Troy School District

**RFP #2425-09 - Addendum #1
BP#2B High School Athletics - Phase #2
January 21st, 2025**

Troy Schools District – RFP #2425-09 BP#2B High School Athletics Renovations - Phase #2

Addendum #1 Bidder Clarifications

DRAWING NO.
LD1.05

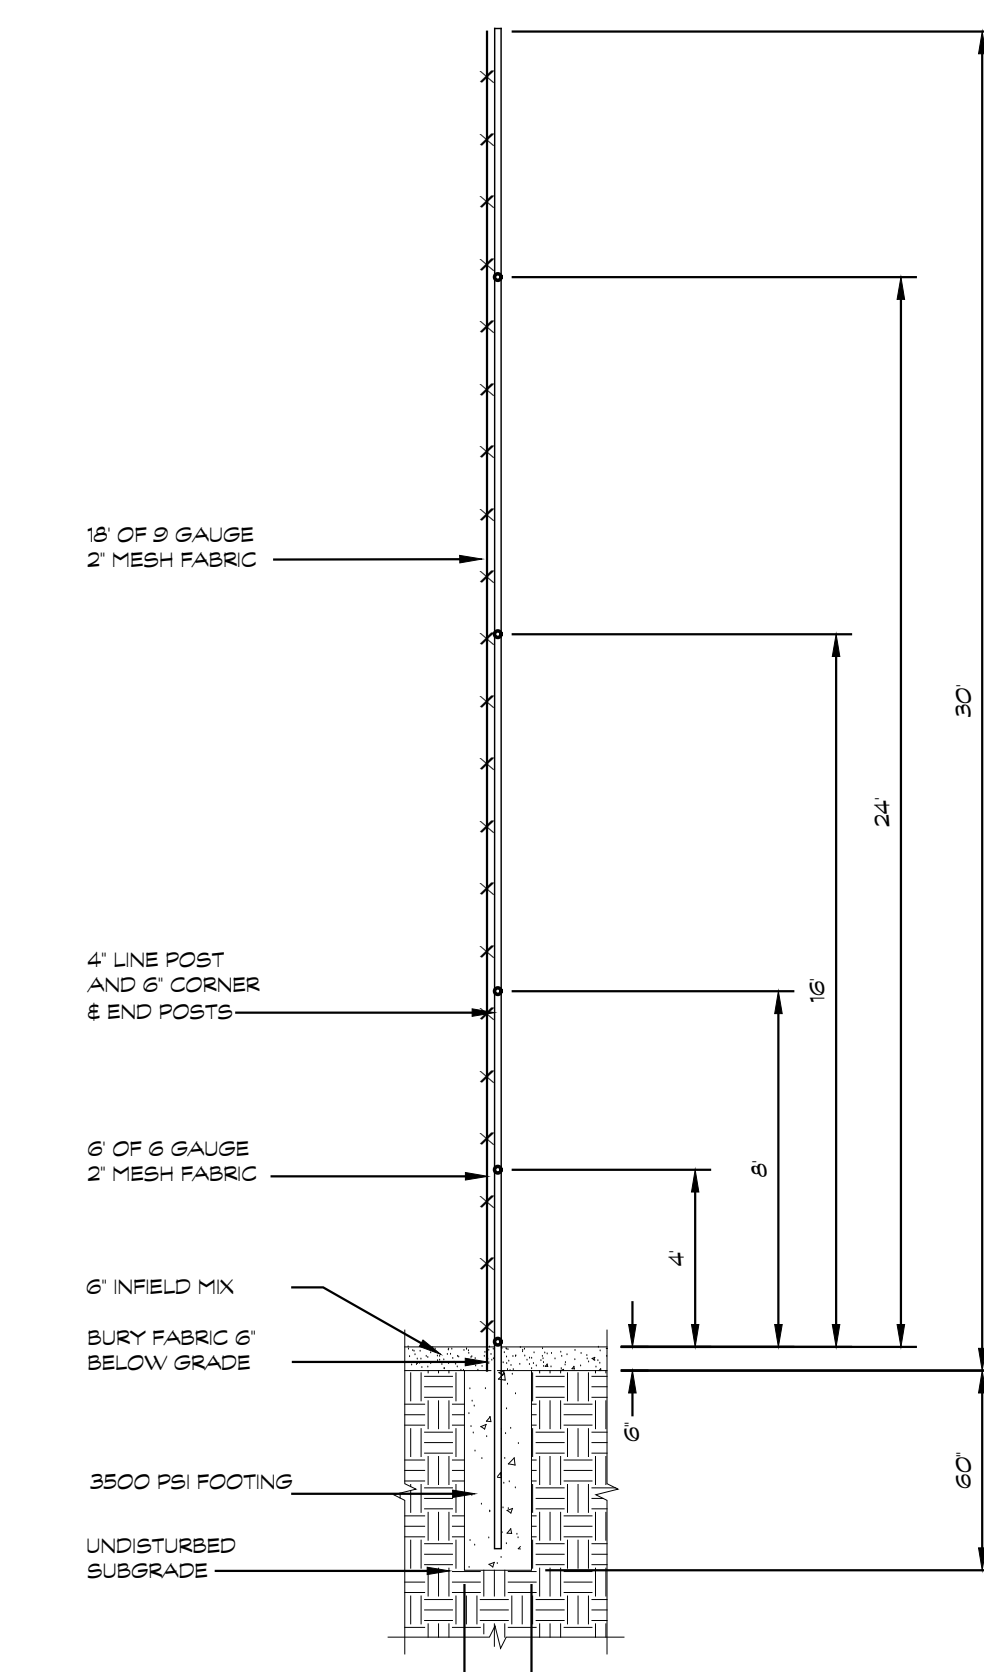
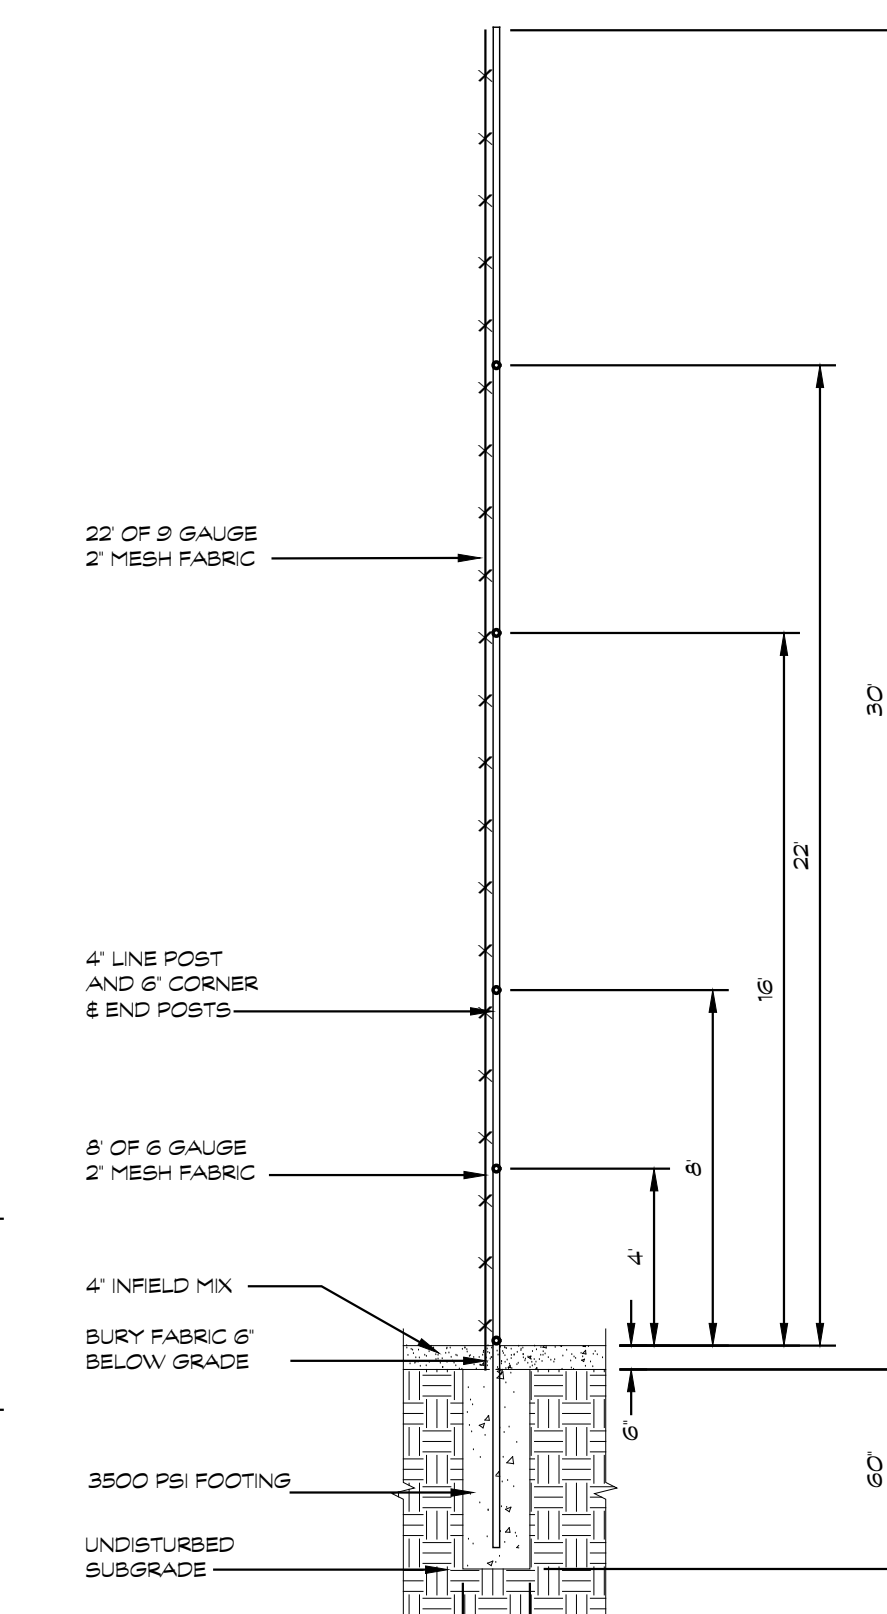
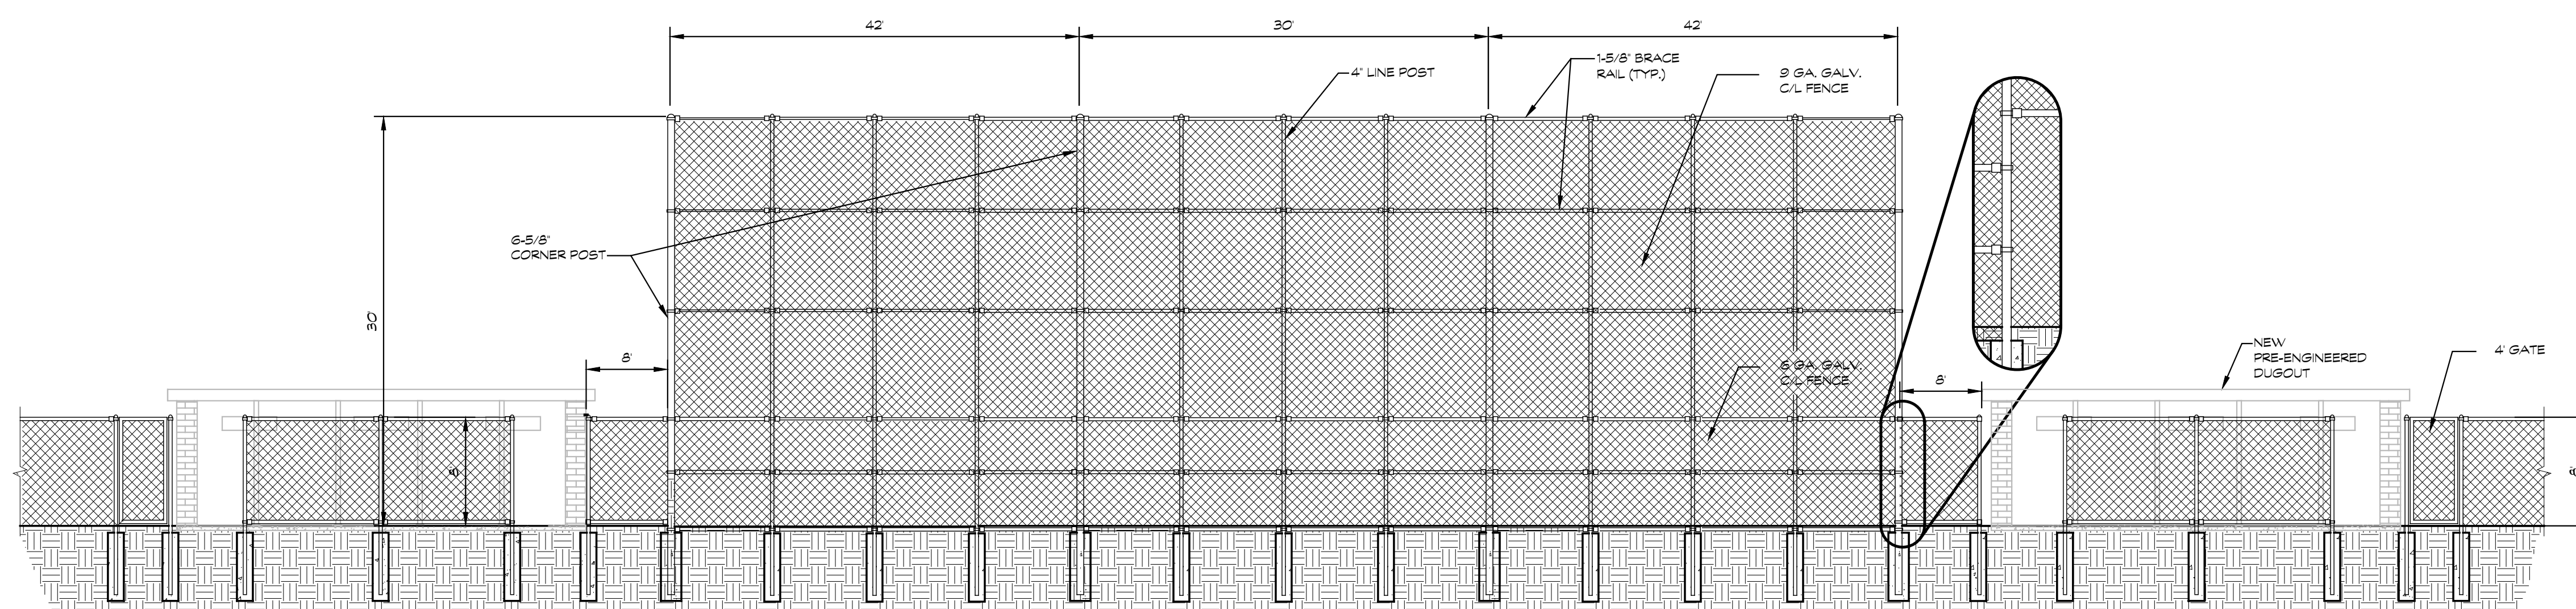
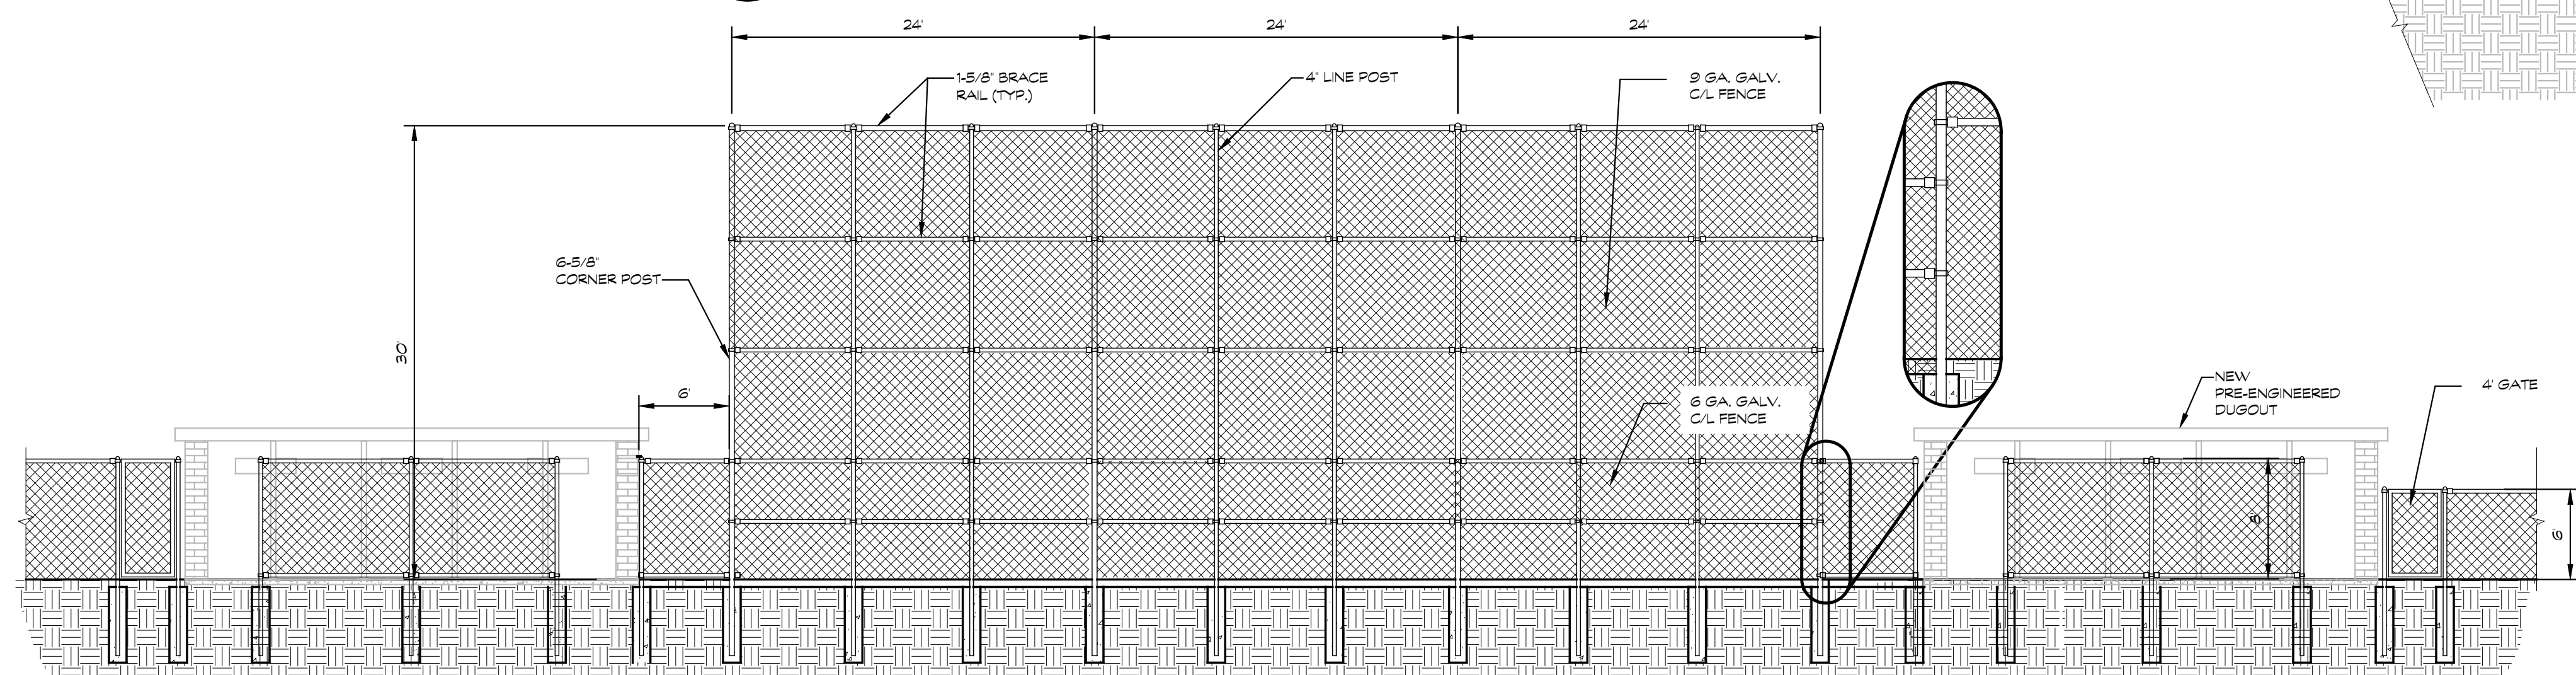
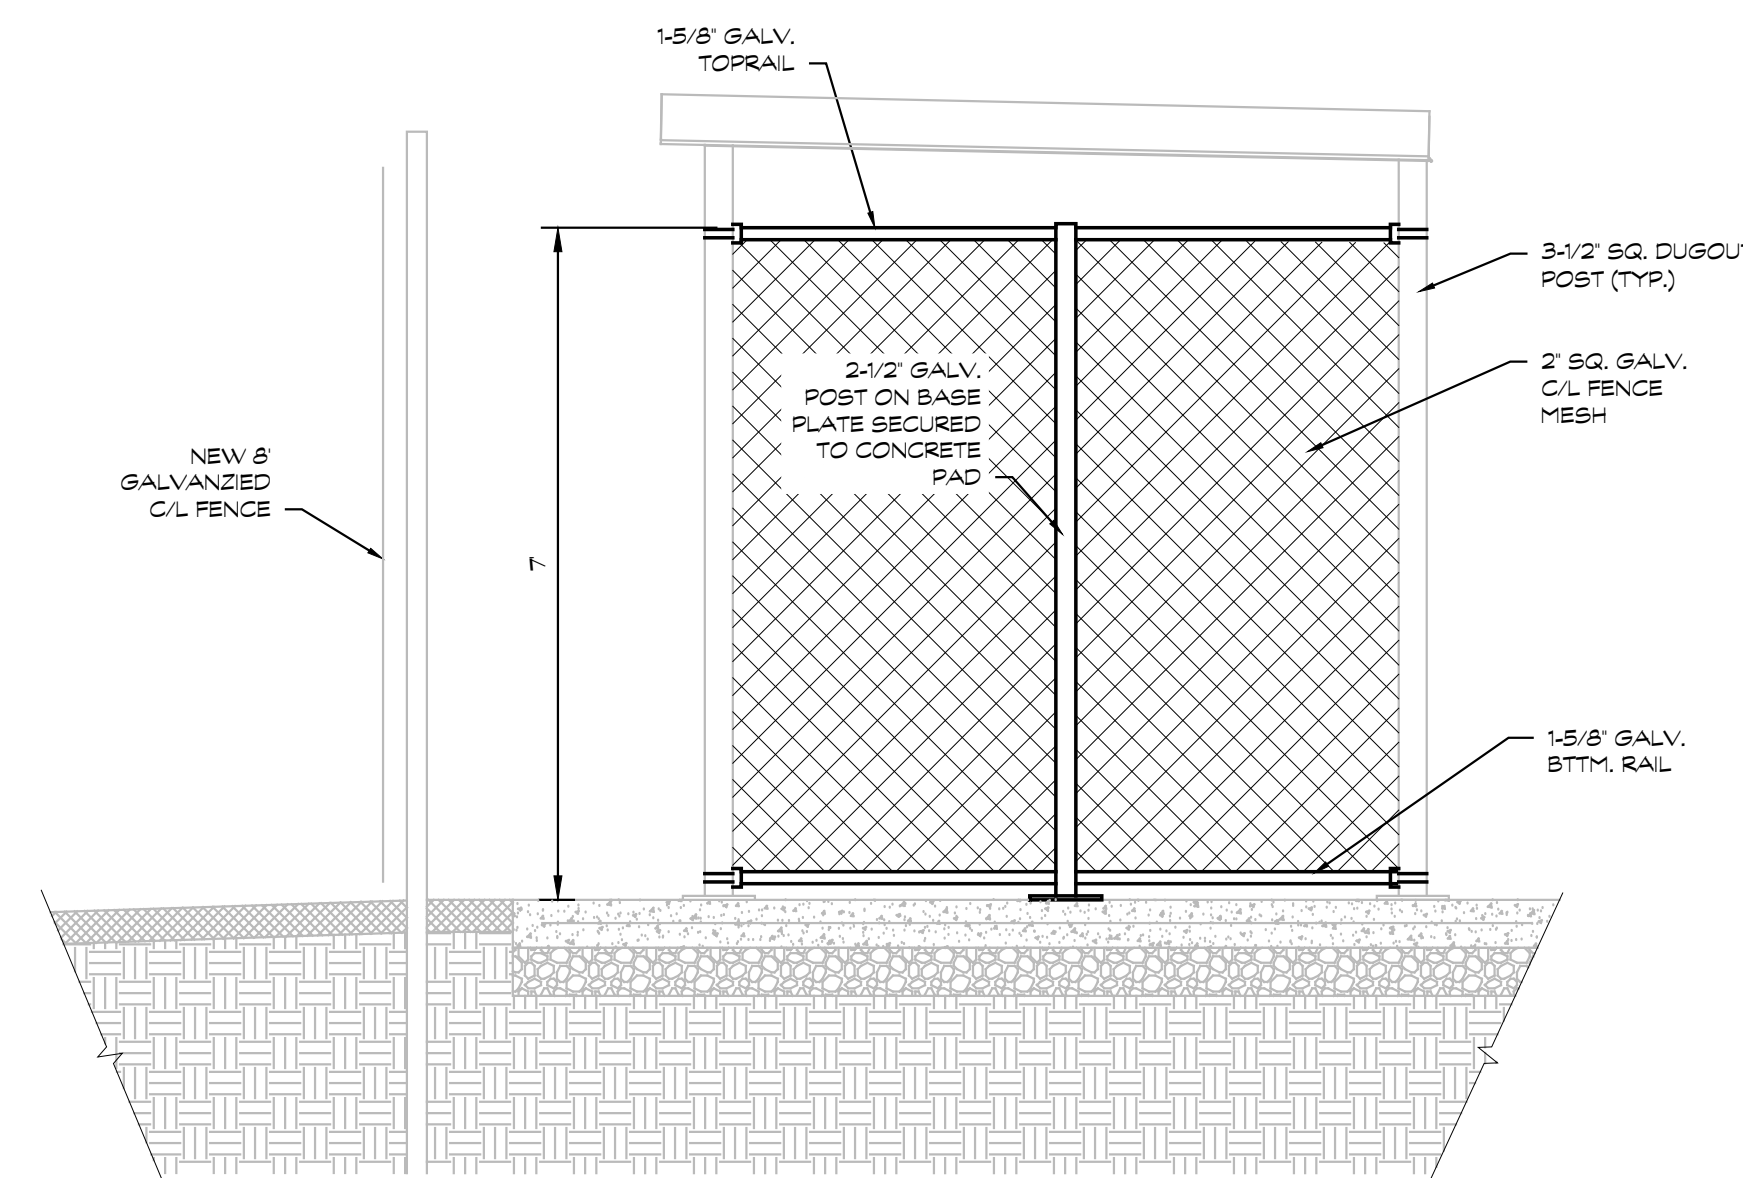
- A. Added note clarifying the intent for post sizes on gates larger than 12' as indicated.
- LD-10 Refer to Drawing No. LD1.08 (reissued):
 - A. Revised details; moved JV dugout details from different LD sheet onto sheet as indicated.
